JAR-22: SAILPLANES AND POWERED SAILPLANES

Please find attached a copy of Amendment 1 to JAR-22, effective 1 August 2001.

JAR-22, Amendment 6, 1 August 2001

FIGURE 1 MANOEUVRING ENVELOPE

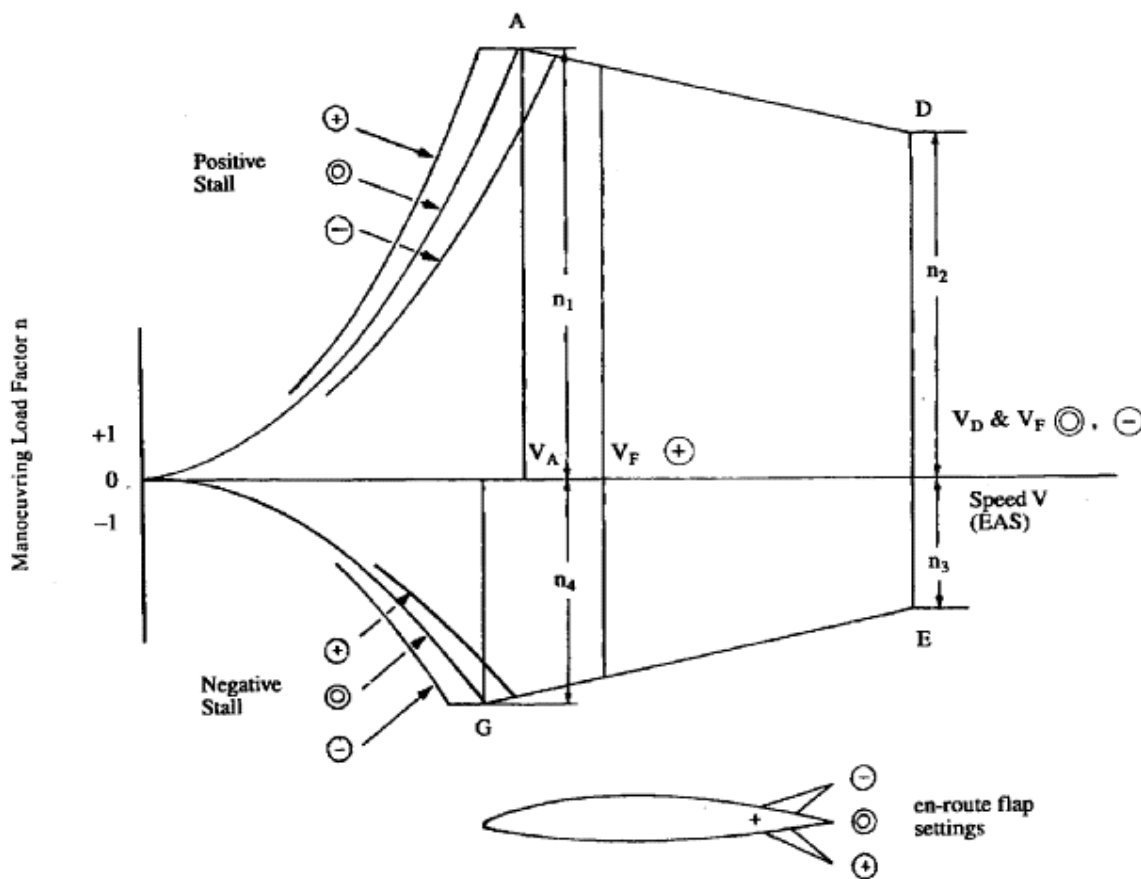
- (a) The introduction of NPA 22C–6, which:–
- (i) corrects the signs in the 'Load Factor Increment' column in the table of Category A – Additional Cases on page C–8; and
 - (ii) indicates manoeuvring load factors n_1 to n_4 in Figure 1, Manoeuvring Envelope, referred to in paragraph JAR 22.333(b).

FIGURE 1 EXAMPLE OF AIR SPEED INDICATOR MARKINGS

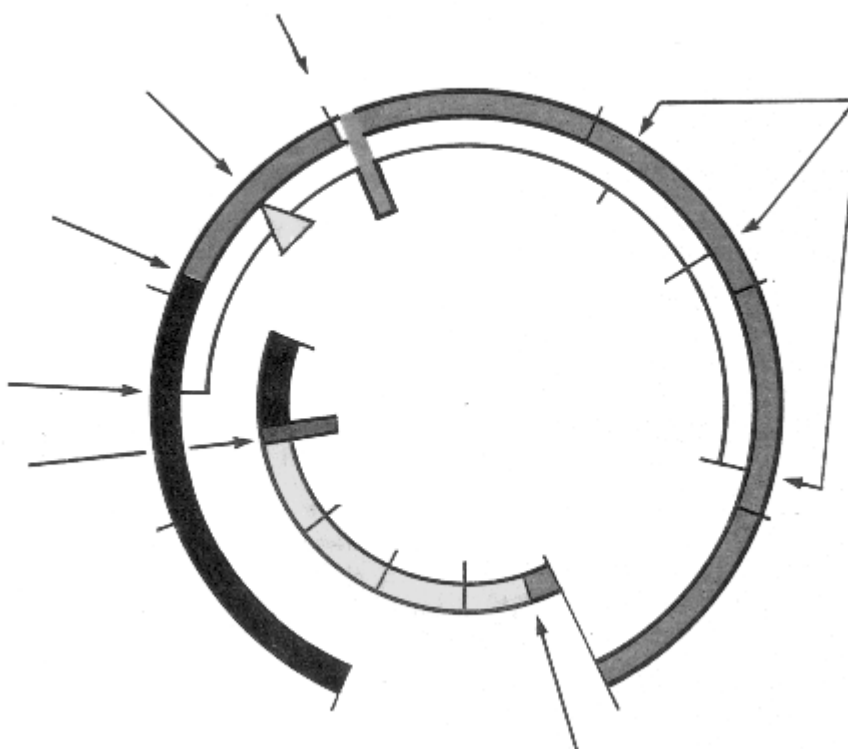
Editorial amendment to the caption of Figure 1 to clarify that the Figure is an example of airspeed indicator markings.
